FLOYD ROAD & GLORE ROAD

SHEET TITLE
MASTER SITE
REZONING PLAN

PETITION NO: Z-44
HEARING DATE (PC): 08-01-17
HEARING DATE (BOC): 08-15-17
PRESENT ZONING: R-20

ZONING COMMENTS:

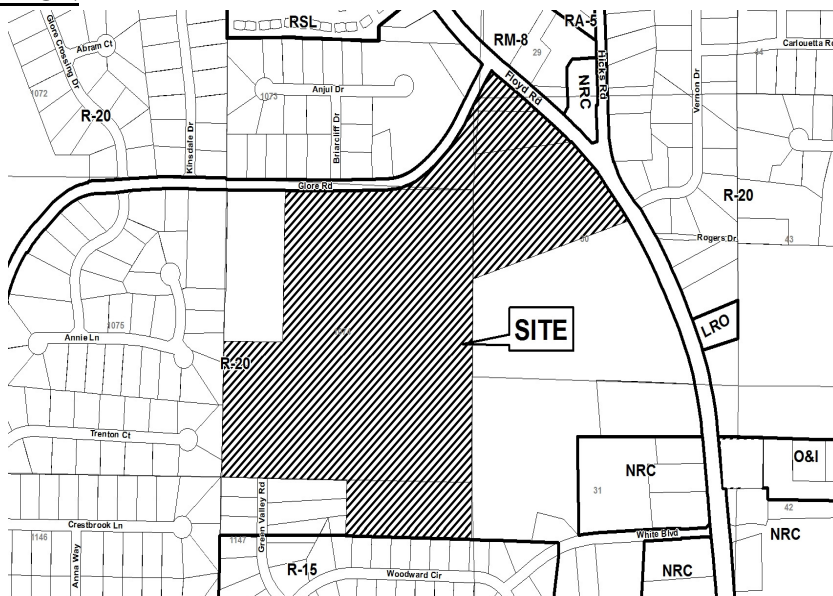
1. Waiver of the front setback along Floyd Road from the required 75 feet for an arterial road to 40 feet; and
2. Waiver of the interior rear setback for the RM-8 detached units from the required 30 feet to 10 feet.

- ☒ FEMA Designated 100 year Floodplain Flood.
- ☒ Flood Damage Prevention Ordinance DESIGNATED FLOOD HAZARD.
- ☒ Project subject to the Cobb County Flood Damage Prevention Ordinance Requirements.
- ☒ Dam Breach zone from (upstream) (**onsite**) lake - need to keep residential buildings out of hazard.

Location: identified on site plan.

2. The existing downstream subdivisions are older and have limited stormwater conveyance capacity with numerous drainage issues and complaints. As a result, it is recommended that stormwater management be elevated such that each storm discharge is controlled not to exceed the allowable discharge of the next lower, more frequent storm event (ie. 5-year storm event released at 2-year rate; 10-year event at 5-year rate; etc. to 100-year event at 50-year rate).

3. The existing lake as well as two stormwater management facilities are proposed to provide stormwater management for the development. The ponds located in the open space as well as the permanent pool lake must be maintained by the mandatory homeowner's association. The existing dam must be brought up to current County design standards.

4. Offsite bypass to the southwest into the Glore Estates Subdivision must be limited to pervious areas only due to the age and limited capacity of the existing stormwater conveyance system.

1. Final site plan to be approved the Board of Commissioners;
2. The RM-8 part of the property be deleted to RA-5 with a maximum of 5 units per acre;
3. The RA-6 and RA-5 part of the property be deleted to R-12 with a maximum density of 2.5 units per acre;
4. Fire Department comments and recommendations;
5. Historic Preservation comments and recommendations;
6. Water and Sewer Division comments and recommendations;
7. Stormwater Management Division comments and recommendations;
8. Department of Transportation comments and recommendations; and
9. Owner/developer to enter into a Development Agreement pursuant to O.C.G.A. §36-71-13 for the dedication of system improvements to mitigate traffic concerns.
